Report: TAB REPORT
Function: Test, Adjust, & Balance
Date: 06/27/2024

PROJECT
06-17-24 CAVA YUKON, OK (10TH ST)

Project: 06-17-24 CAVA YUKON, OK (10TH ST)

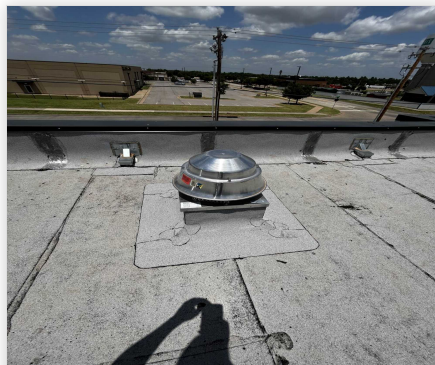
Issue Name : EF2
Description : BACK DRAFT DAMPER IS NOT INSTALLED
Created By : National TAB **Assigned To :** National TAB - Will Turnbough
Status : Open
Priority : Medium **Asset Tag :**
Originated Date : 06/18/2024 - Kristopher Passley - National TAB

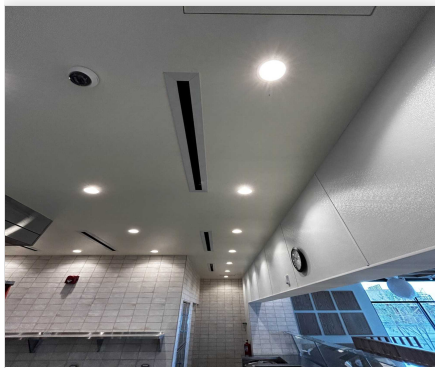
Issue Name : EF2 - AIRFLOW
Description : FAN IS ON HIGH AIRFLOW, NO FAN SPEED CONTROLLER INSTALLED. RECOMMEND INSTALLED SPEED CONTROLLER TO BRING FAN INTO DESIGN.
Created By : National TAB **Assigned To :** National TAB - Will Turnbough
Status : Open
Priority : Urgent **Asset Tag :**
Originated Date : 06/19/2024 - Kristopher Passley - National TAB

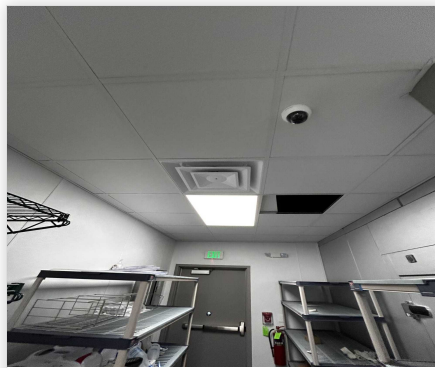
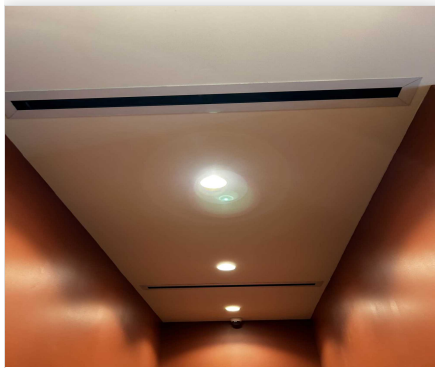
Issue Name : RTU-1 KITCHEN DIFFUSERS
Description : KITCHEN DIFFUSERS 1-1,1-2,1-3 and 1-8 HAVE CLOSED DAMPERS THAT ARE INACCESSIBLE. NEED MECHANICAL TO OPEN OR CHECK FOR BLOCKAGE.
Created By : National TAB **Assigned To :** National TAB - Will Turnbough
Status : Open
Priority : Urgent **Asset Tag :**
Originated Date : 06/20/2024 - Kristopher Passley - National TAB

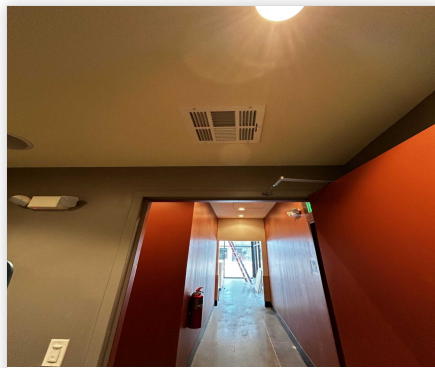
Issue Name : RTU-2 DIFFUSERS
Description : RESTROOM AND HALLWAY DIFFUSERS 2-11, 2-12 and 2-14 HAVE CLOSED DAMPERS THAT ARE INACCESSIBLE. NEED MECHANICAL TO OPEN DAMPER OR CHECK FOR BLOCKAGE.
Created By : National TAB **Assigned To :** National TAB - Will Turnbough
Status : Open
Priority : Urgent **Asset Tag :**
Originated Date : 06/20/2024 - Kristopher Passley - National TAB
